Subject: **ENERGY COMMISSION STAFF'S REBUTTAL TESTIMONY
IVANPAH SOLAR ELECTRIC GENERATING SYSTEM (07-AFC-5)
Exhibit 305**

SUMMARY

Energy Commission staff is providing the following Rebuttal Testimony in the technical areas of Alternatives and Biological Resources. This testimony is organized as follows:

Rebuttal Testimony Figure 8

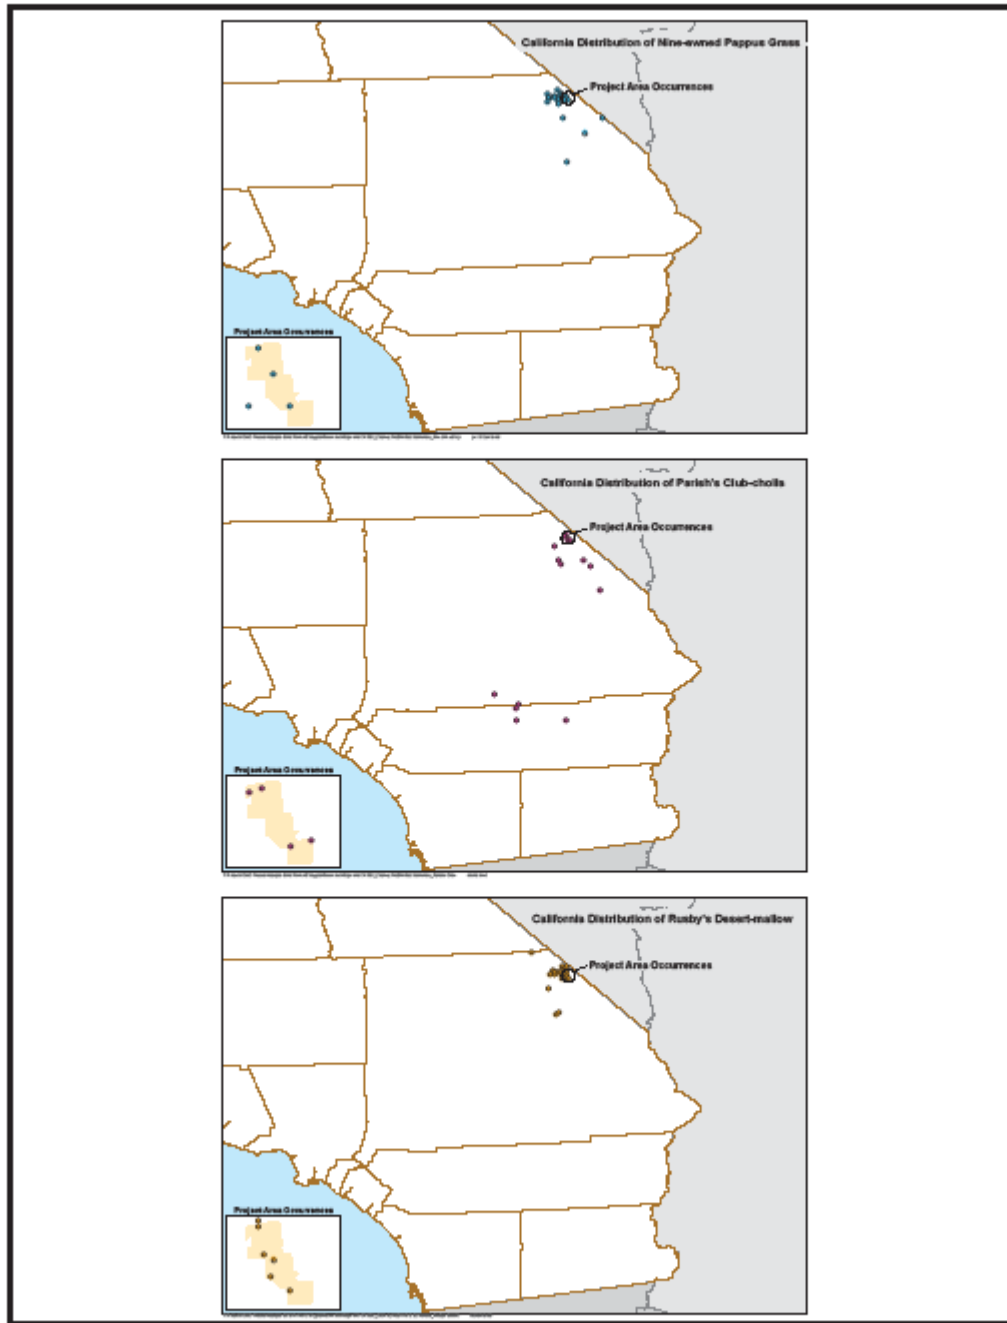
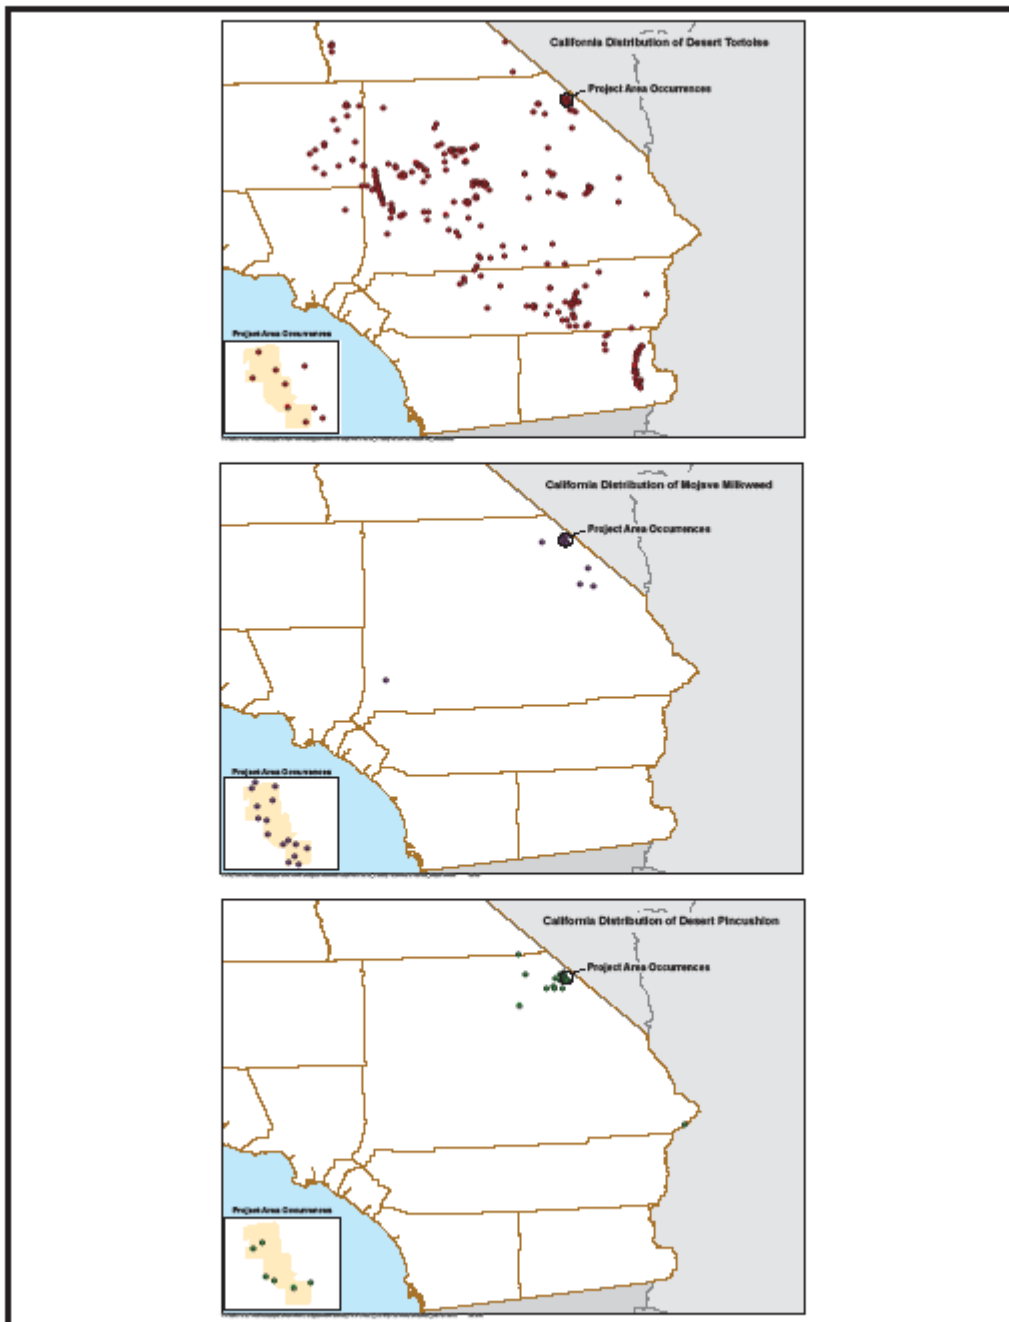
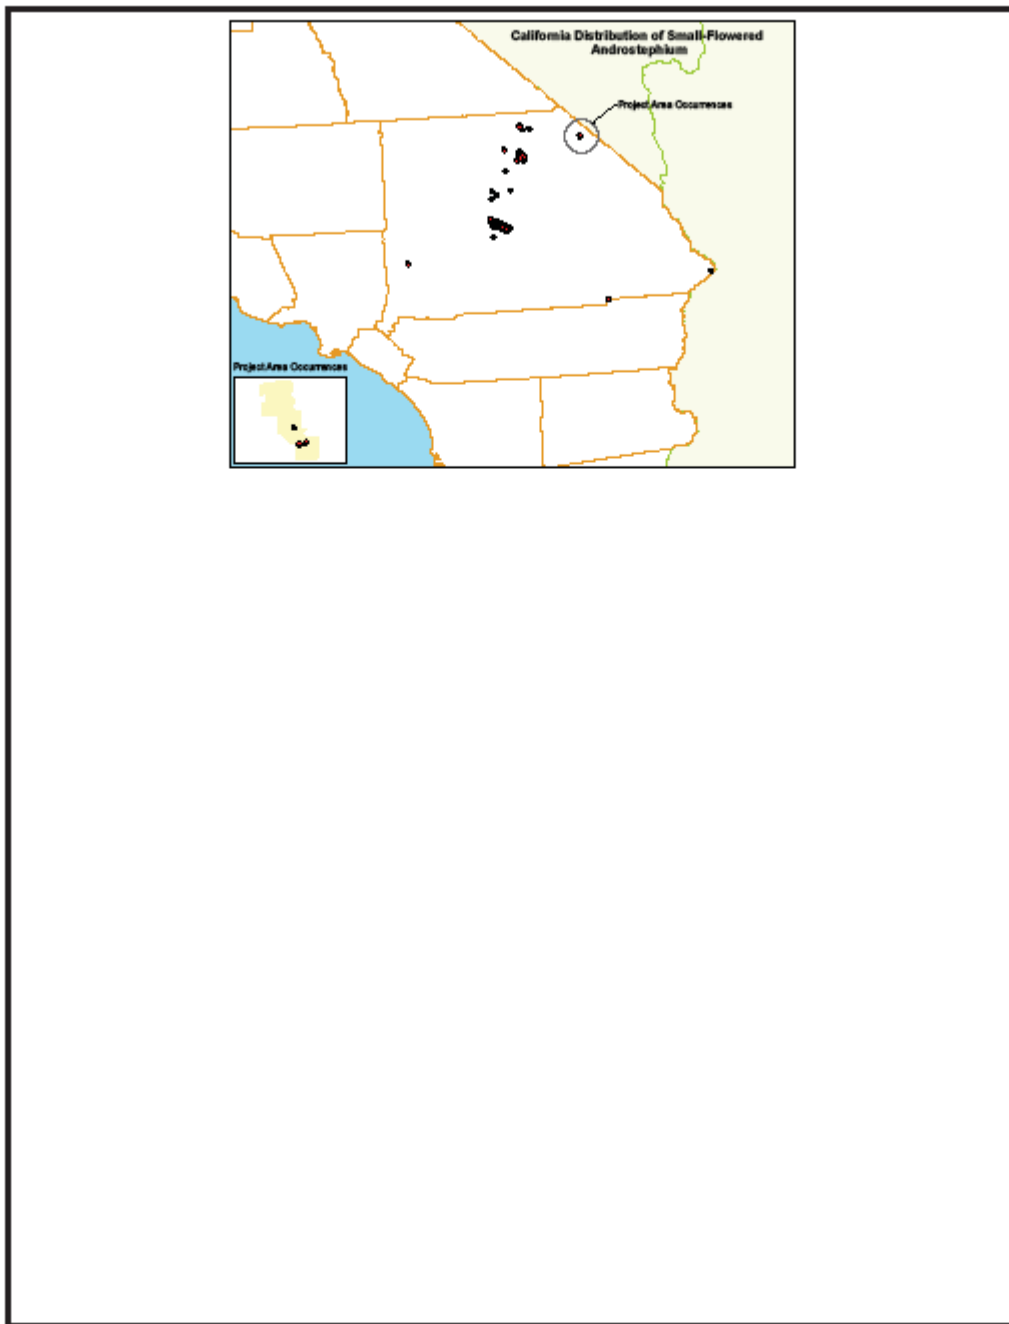
Rebuttal Testimony Figures 8 through 10 provide maps of the California distribution of documented occurrences for all six special-status plant species, including small-flowered androstephium, for which impacts are considered potentially significant in a CEQA context. Rebuttal Testimony Figures 8 and 9 were previously included in the FSA/DEIS as Biological Resources Figures 1A and 1B. Staff prepared **Rebuttal Testimony Figure 11** to illustrate Sierra Club's concern regarding cumulative impacts to small-flowered androstephium (and to other special-status plant species as noted by CNPS) and the potential for its local extirpation from the Ivanpah Valley.
